8.1 **DA 2013/381 - Shop Top Housing (Reside Living), River Street, Ballina.DOC**

PROJECT
RESIDE LIVING BALLINA
 274 RIVER ST BALLINA
 BALLINA NSW 2460
 DRAWING TITLE
RESIDE@BALLINA PL
 LEVEL 2 FLOOR PLATS

DA NO: DA 2013/381
APPLICANT: Planners North
PROPERTY: Lot: 10 DP: 244352, Lot: 1 DP: 499510, 274 River Street BALLINA
PROPOSAL: To Demolish the Existing Sundowner Motel and Restaurant and to Erect and Strata Title a Multi-level Mixed Commercial and Residential Building with an Overall Height of Approximately 23 metres. The Development Comprises Commercial Premises at Ground Level Fronting River Street and a Restaurant Fronting the River with 36 Residential Apartments above. The Proposal Seeks to Dedicate Land for Foreshore Public Access, Retain Two Existing Trees, Comprising One Norfolk Island Pine and One Pandanus and Incorporate Two Levels of Car Parking Within the Building.

1 LEVEL 2 FLOOR PLAN
SCALE 1:400

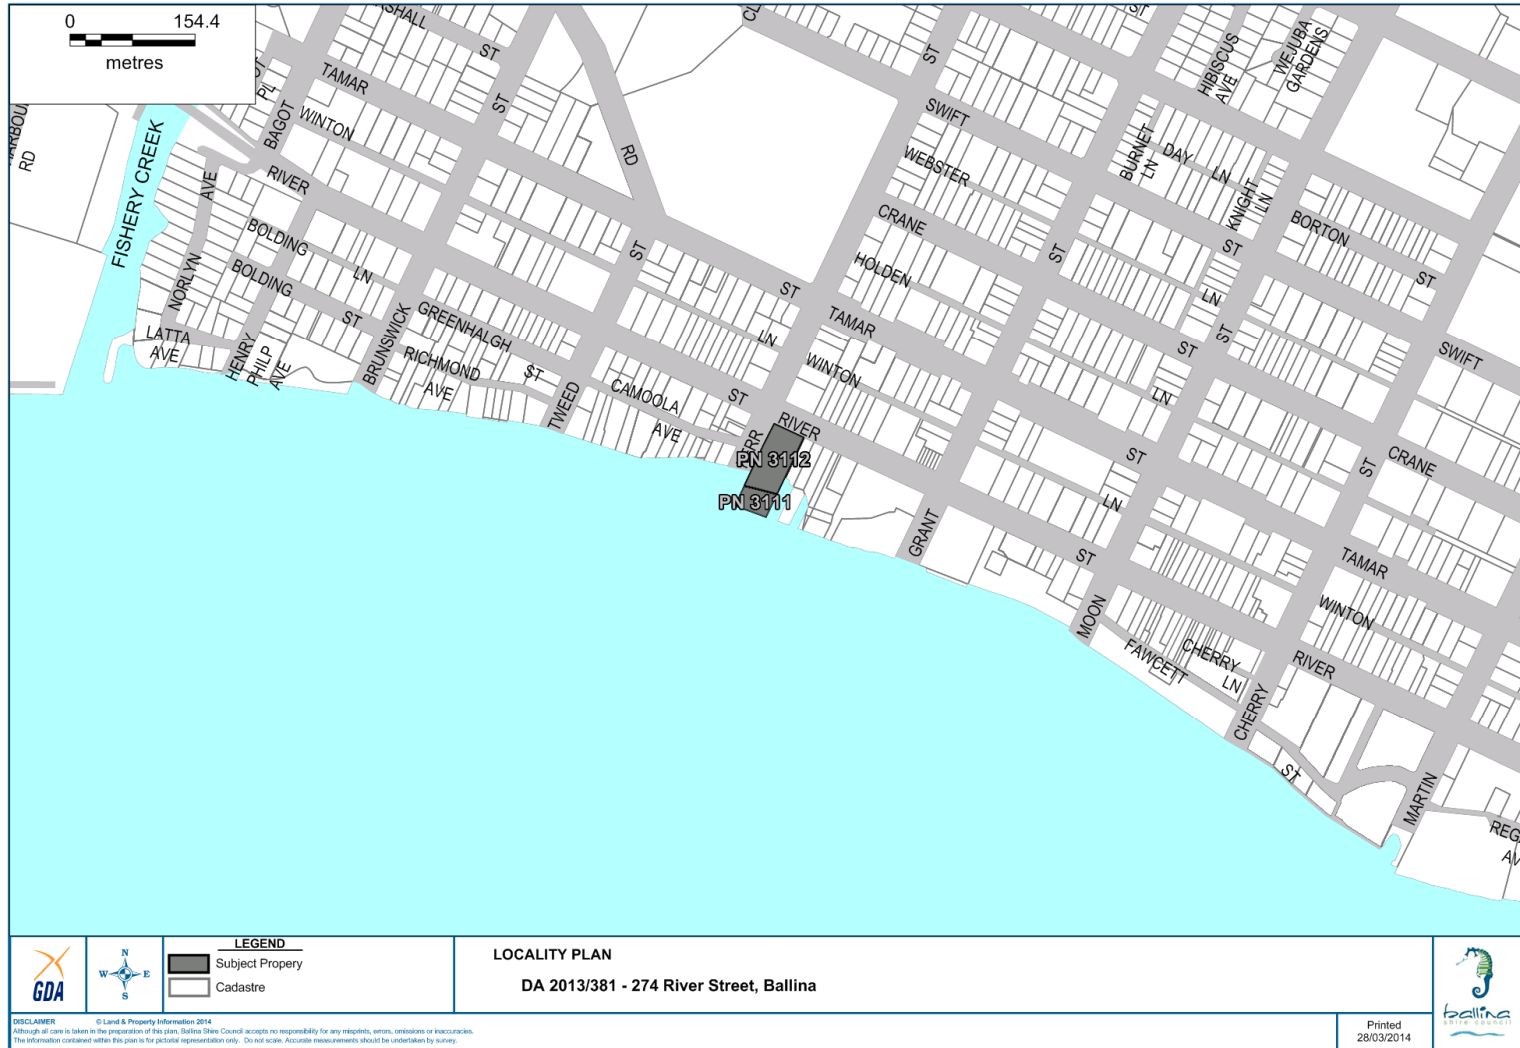
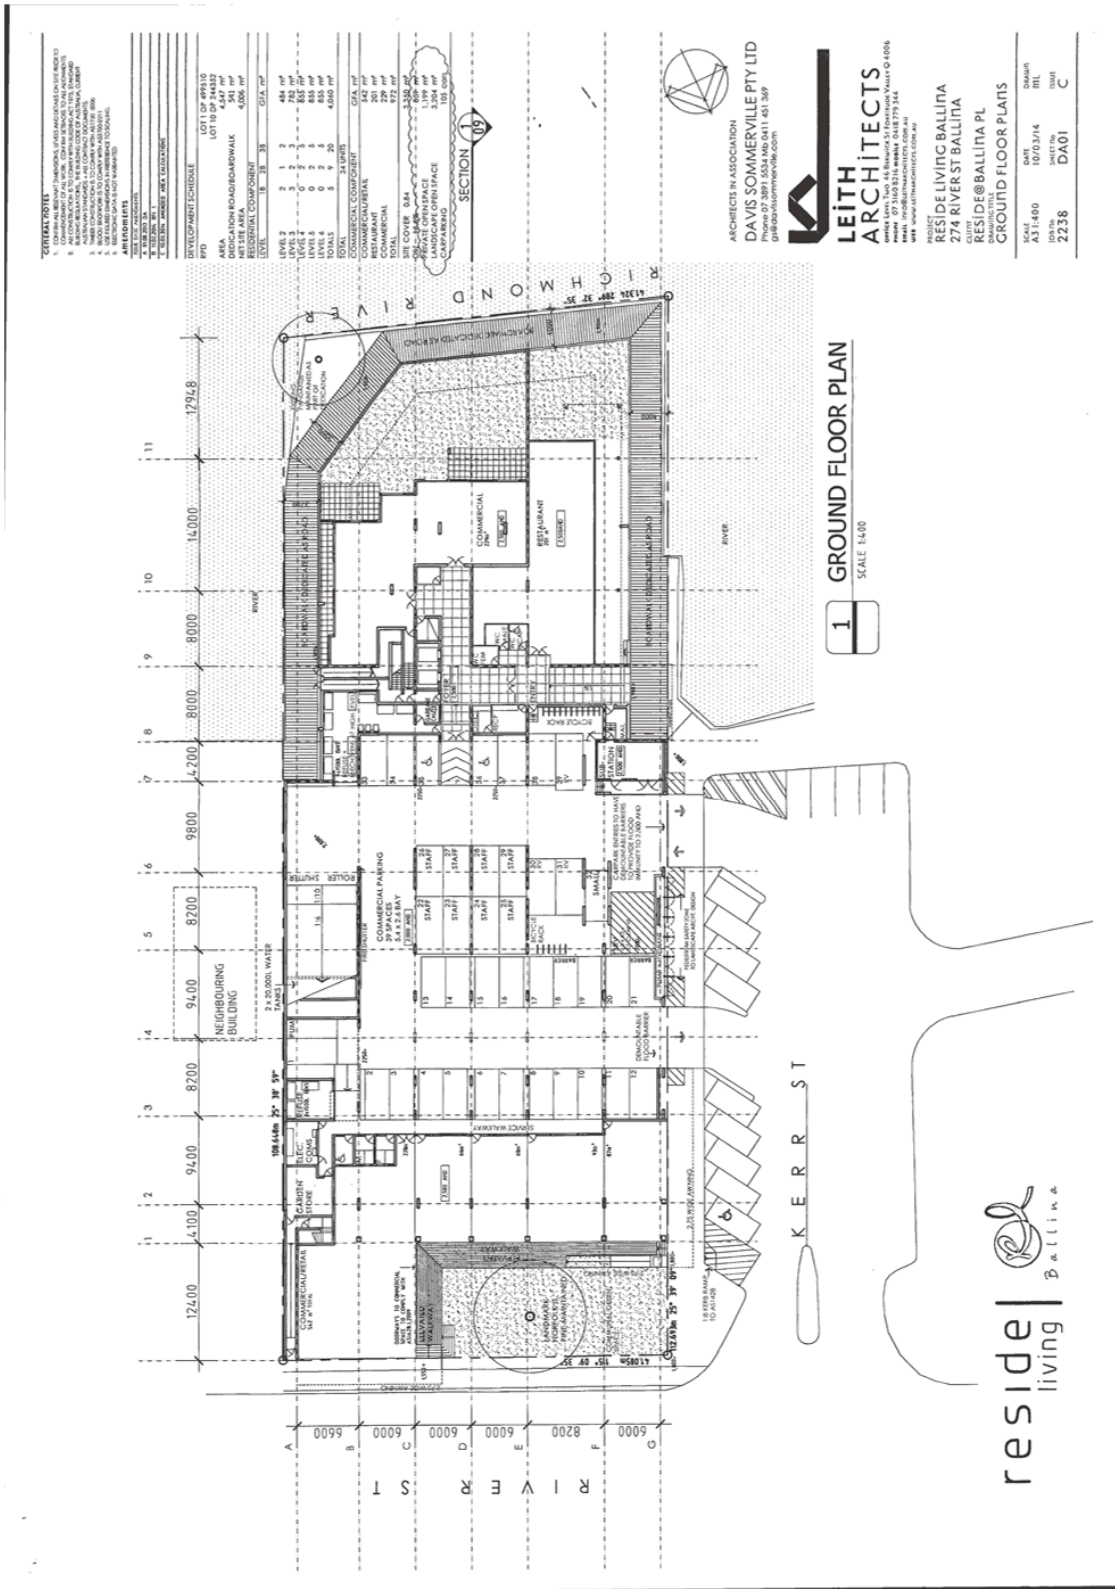
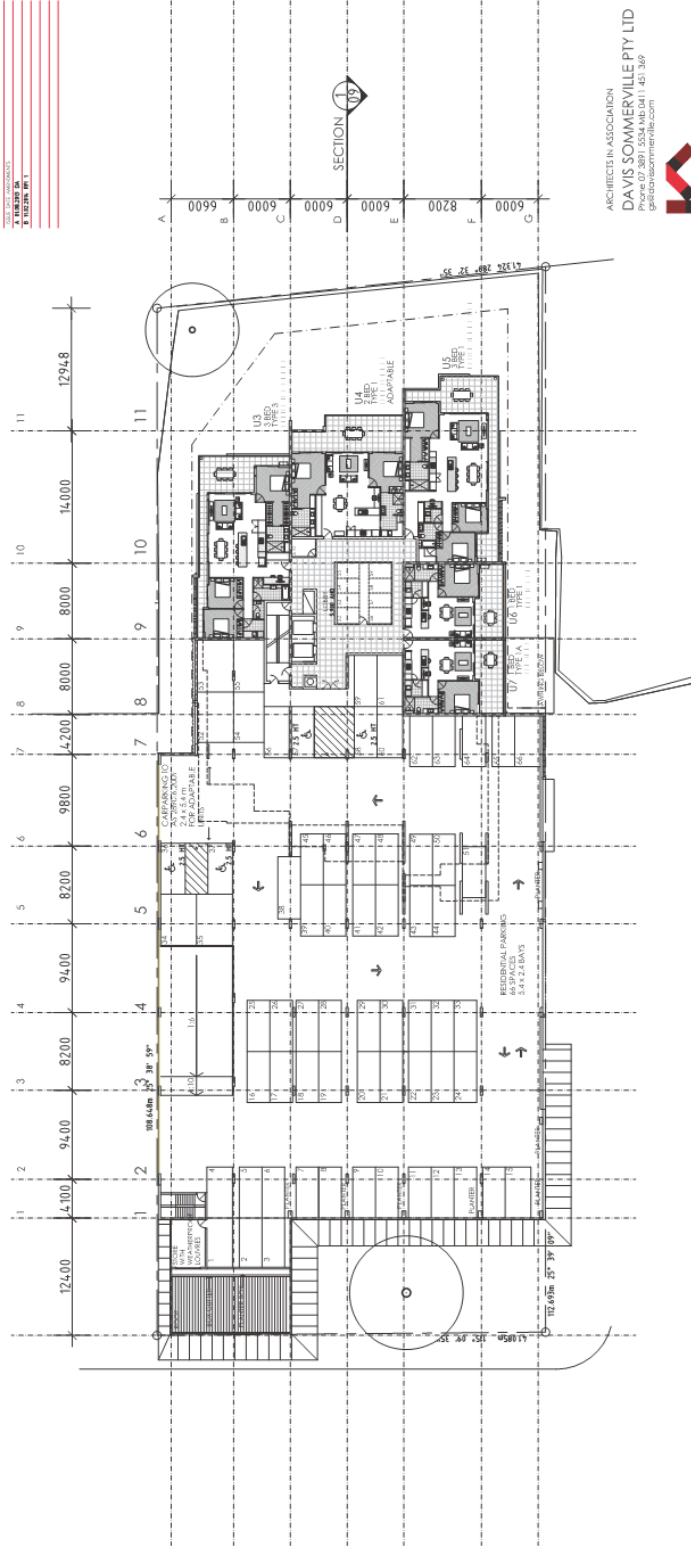
17. Prior to the issue of a Construction Certificate, amended plans of the proposed development are to be prepared deleting the vents as shown on the eastern boundary of the Level Two Car Parking Area. Alternate vents and/or a ventilation system is to be provided as part of the development to ensure compliance with the Building Code of Australia. The plans and specifications for either the mechanical or natural ventilation are to be accompanied by calculations, noise level emissions and if required, design of noise control measures and are to be submitted to and approved by Council prior to the issue of a Construction Certificate.

- 66 approved spaces shall be provided on Level Two as shown on the plans prepared by Leith Architects, Job No: 2238, Sheet No: DA03, Issue: B, Dated 11/02/14. These spaces shall be allocated to the residential apartments of the development.
